PLANNING BOARD MEETING
CITY OF ST. PETE BEACH
COMMISSION CHAMBERS

4. Action Items -
   a. Conditional Use Permit #23033 (Resolution 2023-27): Tradewinds Resort (5600, 5700, 5750, 5800, 5900, 6000 Gulf Blvd)

PLANNING DIVISION
CONDITIONAL USE APPLICATION
STAFF REPORT TO THE
CITY OF ST. PETE BEACH PLANNING BOARD

CASE NO.: 23033 **MEETING DATE:** March 18, 2024
OWNER/APPLICANTS: S. Elise Batsel, Esq. c/o Stearns Weaver Miller for 5500-5600 Gulf Blvd. IG LLC, 5700 Gulf Blvd. BR LLC, 5750 Gulf Blvd. CR LLC, Reef Resort Condominium Association, Inc., 5750 Gulf Blvd. CR LLC, and 6000 Gulf Blvd. SP LLC
PREPARED BY: Brandon Berry, Planner
This application is a request for a Conditional Use Permit:

C-2.3

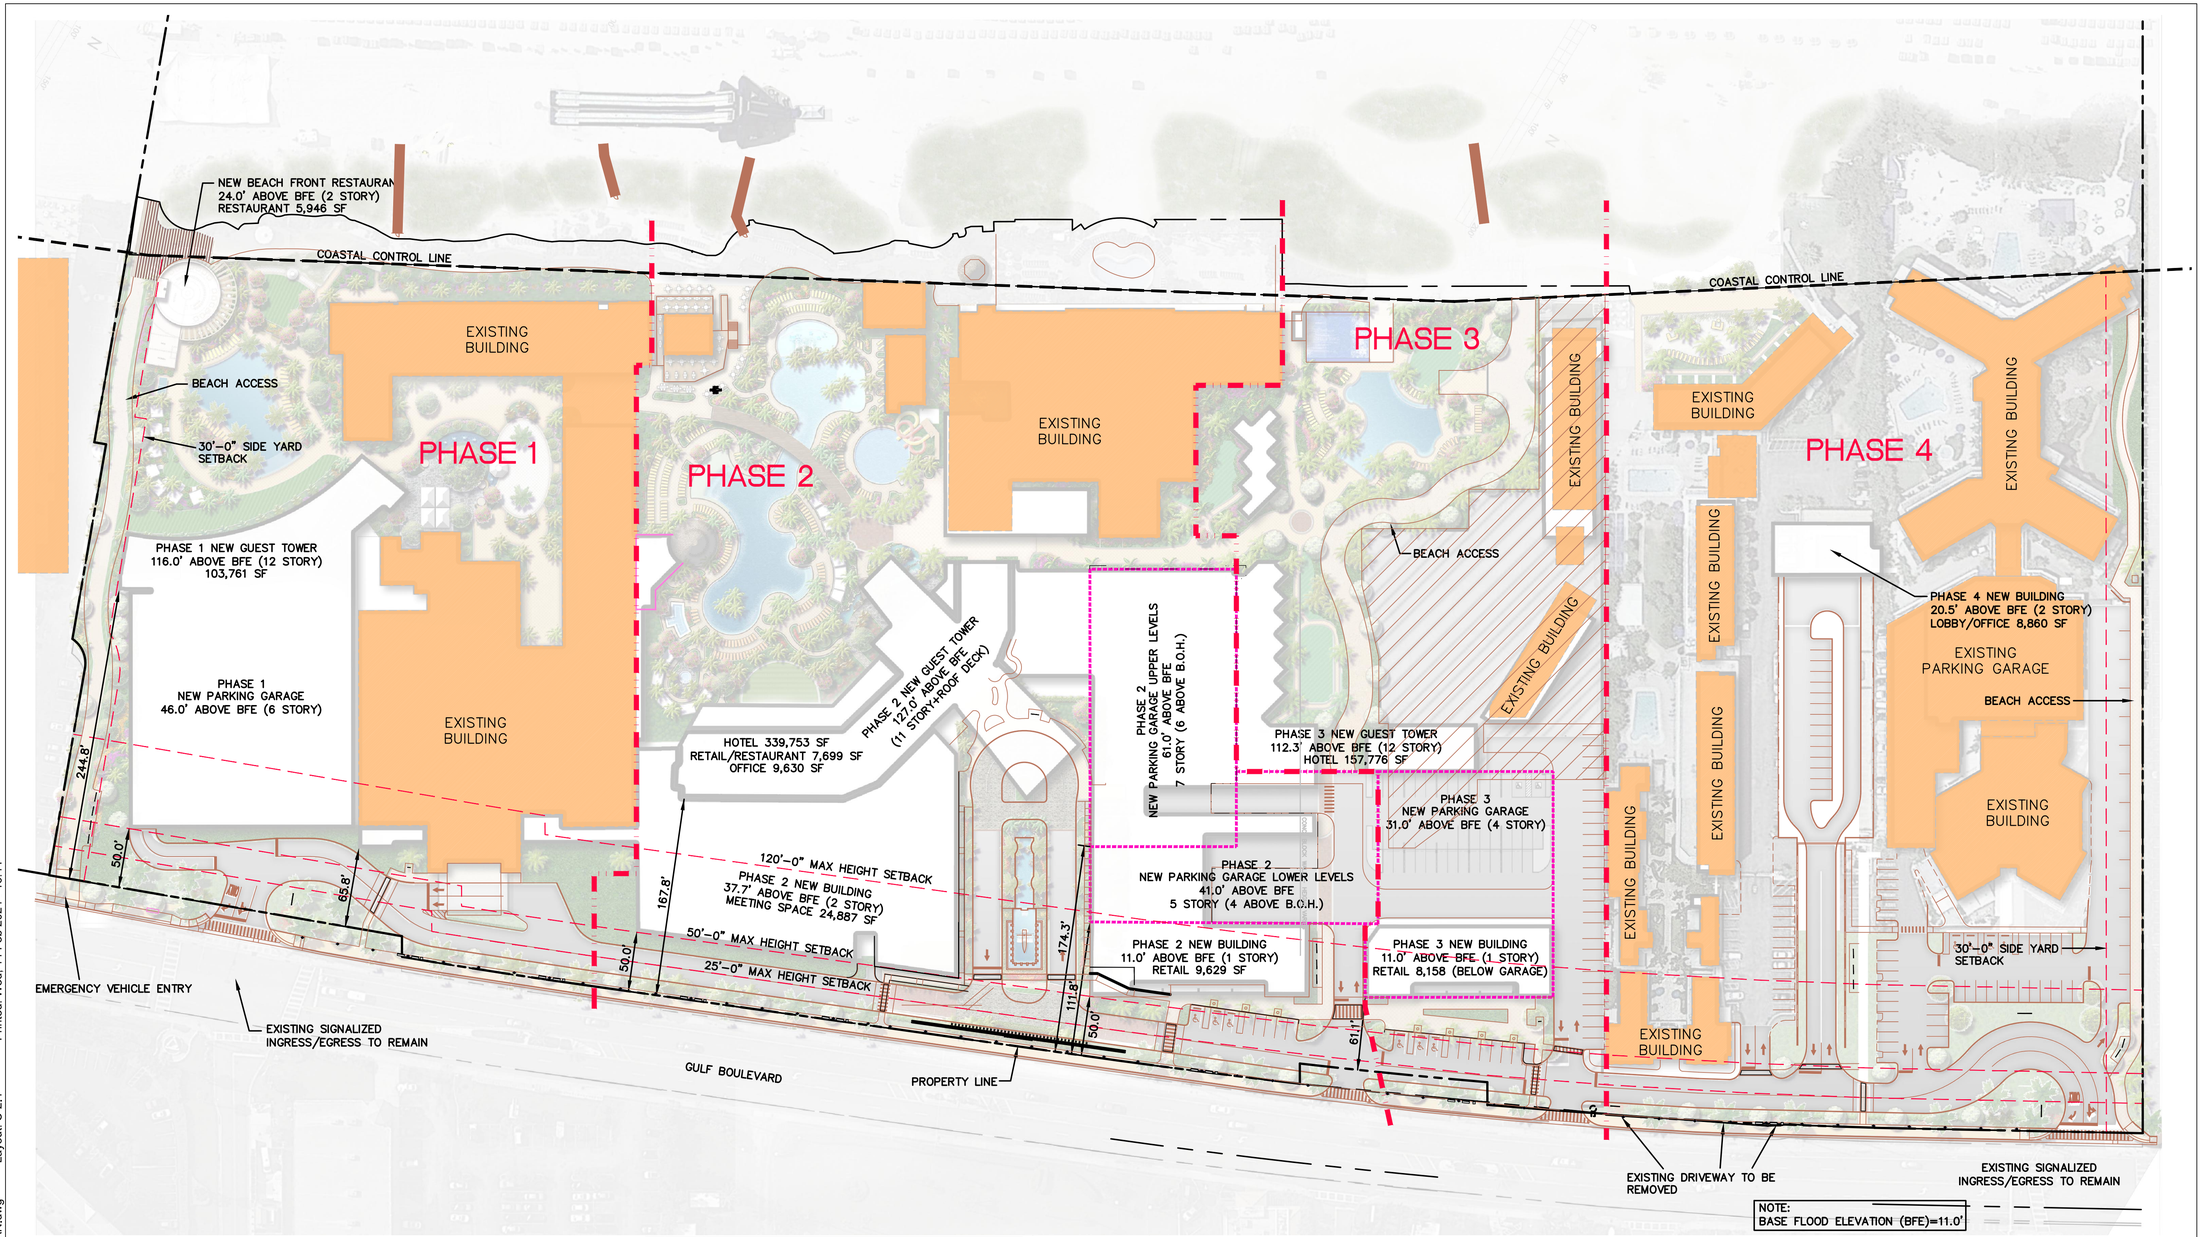
5) Conditional use approval for this project shall not be construed to authorize the approval of any structures seaward of the CCCL for which FDEP and future, separate city approvals are required. Maintenance of existing spaces, such as the pool and deck, may be permitted pursuant to LDC Sec. 25.3. Is a new pavilion proposed behind Rumfish (see Phase IV plan)?	7/31/2023	HE/NMDA		The structure shown on Civil Phase IV, sheet C-2.4 was a mistake and was removed from Phase IV Civil document.
